Westinghouse
Electric Corporation

NSD-NRC-97-5148
DCP/NRC0882
Docket No.: STN-52-003

SUBJECT: INFORMAL CORRESPONDENCE

Subject: Advance Copy of Revised AP600 Technical Specification 3.7.6

Figure 3.7.2-18 (Sheet 1 of 2)

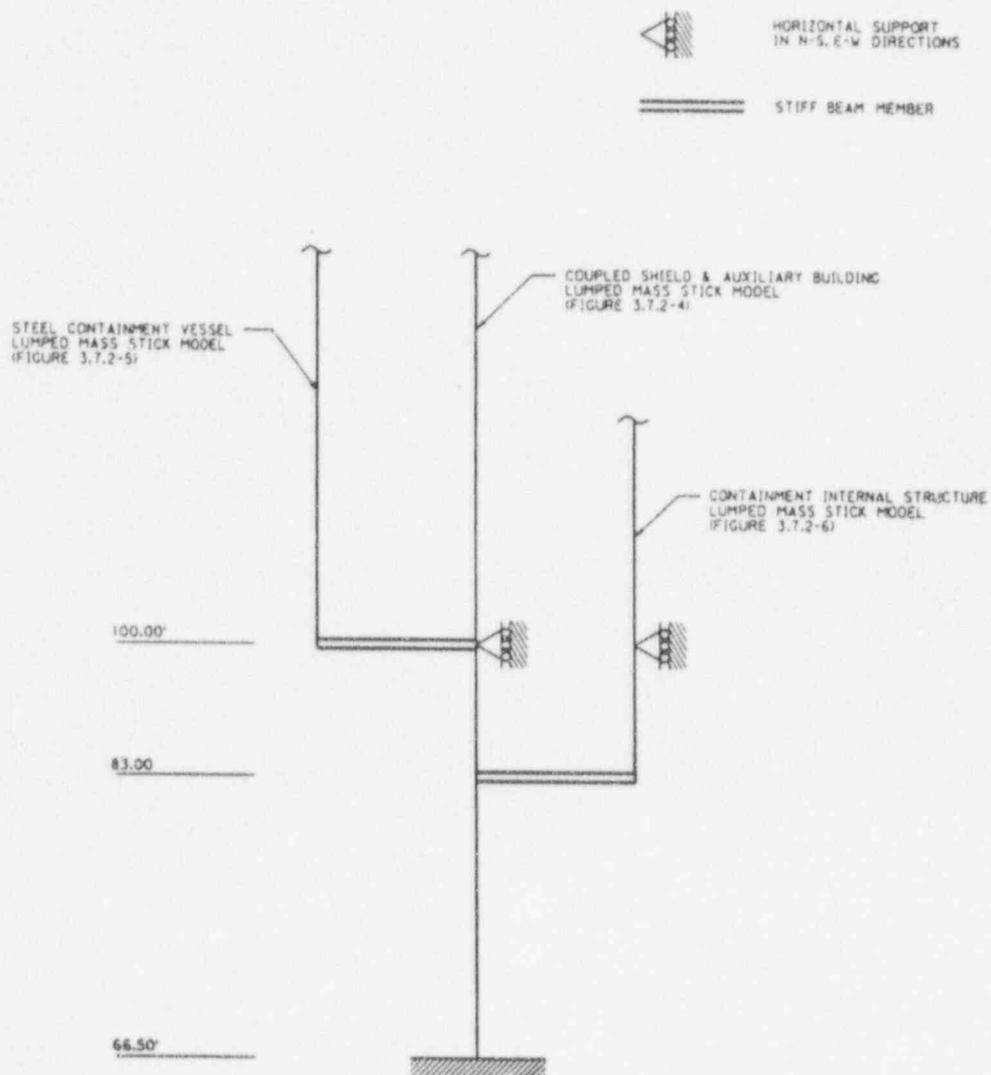
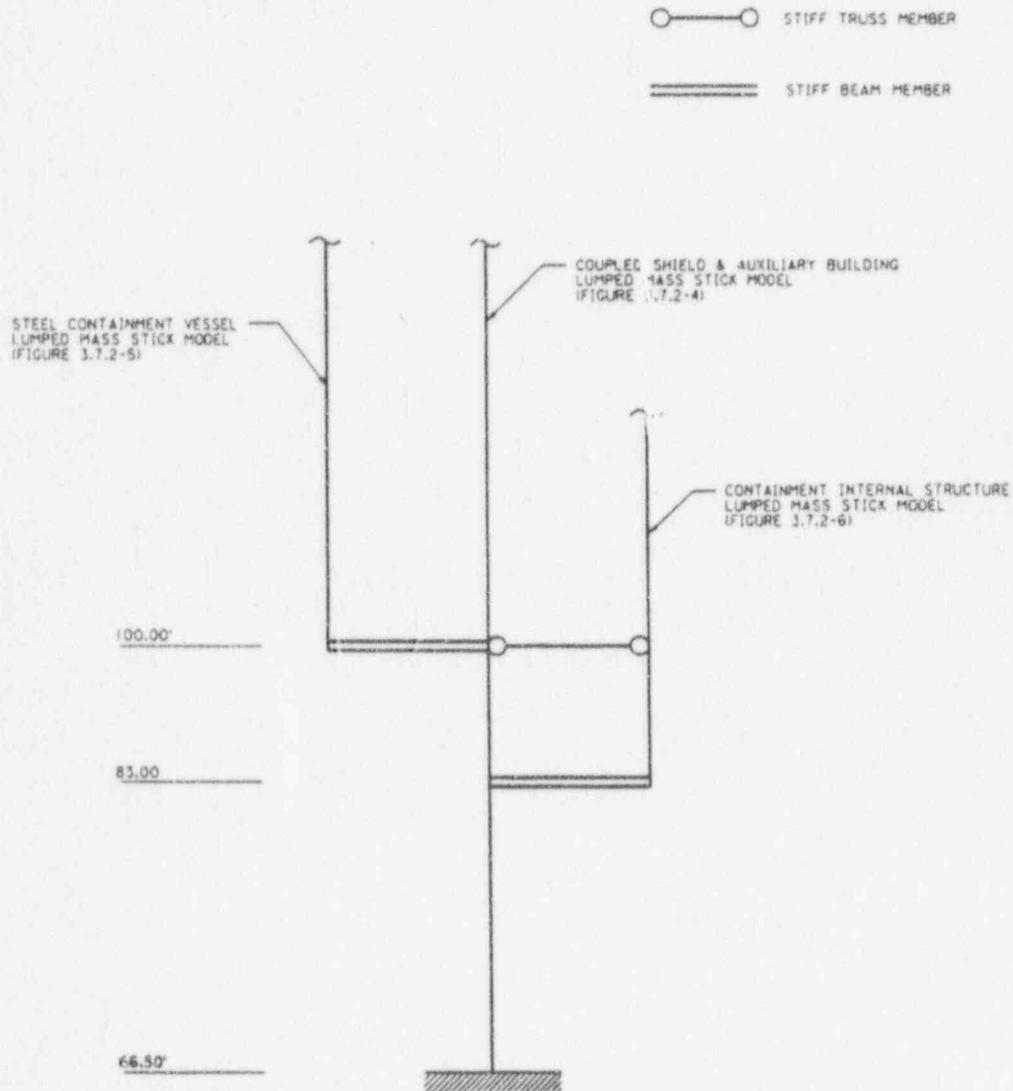
"Correction in Figure 3.7.2-18 of SSAR Rev. 9

The staff indicated that Elevation 85.5 ft., shown in Figure 3.7.2-18, seems to be inconsistent with Elevation 82.5 ft., shown in Figure 3.7.2-6. Also, Figure 3.7.2-18 seems to lack a lateral support at Elevation 82.5 ft. Westinghouse agreed to examine these apparent discrepancies and update the SSAR accordingly."

The figure will be revised in SSAR revision 12. Draft changes were provided in letter NSD-NRC-97-5041, dated March 27, 1997.
